TRANSMITTAL OF RESPONSES TO THE OHIO ENVIRONMENTAL PROTECTION AGENCY AND UNITED STATES FISH AND WILDLIFE AGENCY COMMENTS AND THE GRADING PLAN FOR ACCELERATED RESTORATION OF THE ON-SITE DISPOSAL FACILITY BORROW AREA

RESPONSES TO OHIO ENVIRONMENTAL PROTECTION AGENCY COMMENTS ON BORROW AREA DRAWINGS 90X-5500-G-00619 AND –00620 (20104)

ON-SITE DISPOSAL FACILITY
BORROW AREA-SUBAREA IA, IB & 2
INTERIM RESTORATION PLAN

PLAN - BORROW SUBAREAS IA, IB & 2

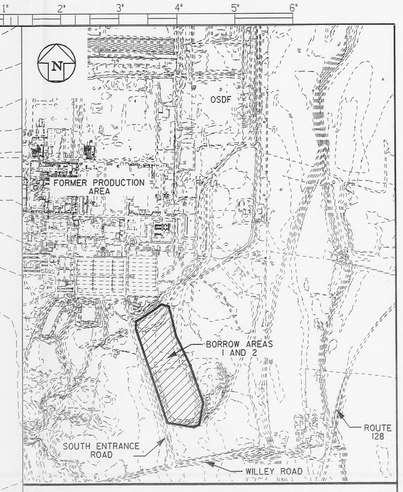
Comment: Why is no topsoil being proposed for placement below elevation 571? It appears to Ohio EPA that Subarea 2 will act like a large mudflat with water levels receding over the course of the summer. The area should be covered with at least a 6-inch layer of topsoil to support vegetation during drying periods. Considering the large quantity of available topsoil, this shouldn't be difficult to obtain.

Comment: The proposed placement of silt fence probably doesn't provide much benefit to the project and should be eliminated. It simply places an additional maintenance burden without providing any tangible environmental benefit considering the area is designed as a sediment basin. Silt fence should be installed along the eastern project area where drainage from the clay screening area stockpiles may impact the restoration.

Response: It is anticipated that the portion of Subarea 2 below elevation 571 will be covered with at least a foot of water on a permanent basis. Given the water level that has been maintained in the sediment basin of the Borrow Area, it is expected that the same water levels will be maintained in Subarea 2. It is possible that the area will dry out in drought conditions, such as those experienced in the summer of 2002. The area was inundated in late summer and fall until pumping was initiated to dry the area out for grading. Because the area will be covered with water, there are no plans to cover the entire area with topsoil or seed the area. This is consistent with the approach taken in other restoration areas where permanent inundation is expected. Some topsoil can be added in the area immediately adjacent to the 571 contour where elevations may be sloping and less than 1 foot.

Action: Some topsoil will be added in the area immediately adjacent to the 571 contour in the event that some drying occurs in the summer months. The area will be observed over the next summer. If drying does occur in the area immediately adjacent to the 571 contour, this area will be seeded per the seeding specification.

Response: These silt fences are intended to be installed after topsoil placement in the upslope areas to avoid washout into the basin area. However, the washout would be minimal therefore the silt fences will be eliminated from the drawings. There is no silt fence shown at the toe of the clay stockpiles because these piles will be treated with surfactant.

Action: The silt fences will be removed from the drawings.

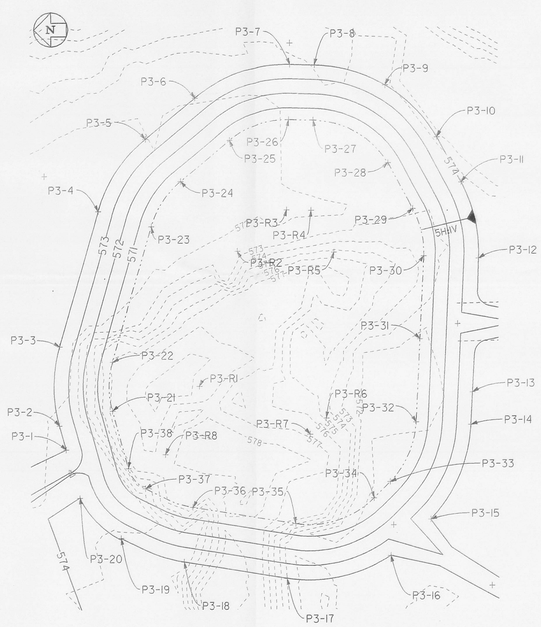
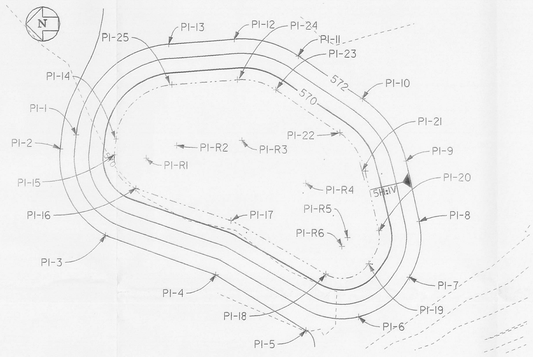
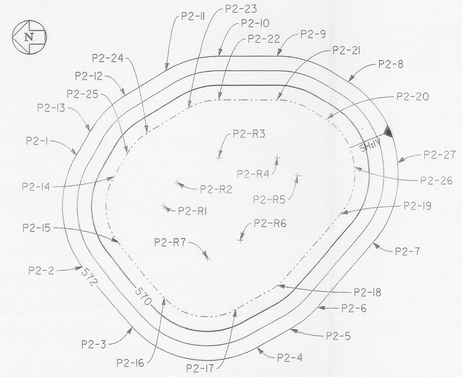
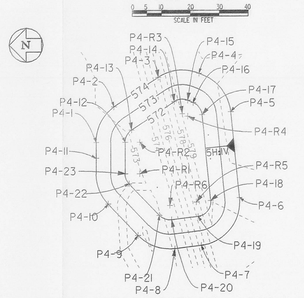
Commenting Organization: Ohio EPA Commentator: OFFO
Section #: Drawing –00620, Island Typical Pg. #: NA Line #: NA Code:
Original Comment #: 4
Comment: The drawing calls for a "minimum 2-foot" vertical elevation. Our previous comments recommended the islands but with a 2-foot maximum elevation. The drawing should be revised to ensure construction personnel do not create islands that are too high.

Response: Agreed. The intent is to create the island with an elevation of no more than 2 feet.

Action: Island will be constructed at an elevation no greater than 2 feet. The notation on the drawing will be revised to indicate that the island will be a maximum of 2 feet.
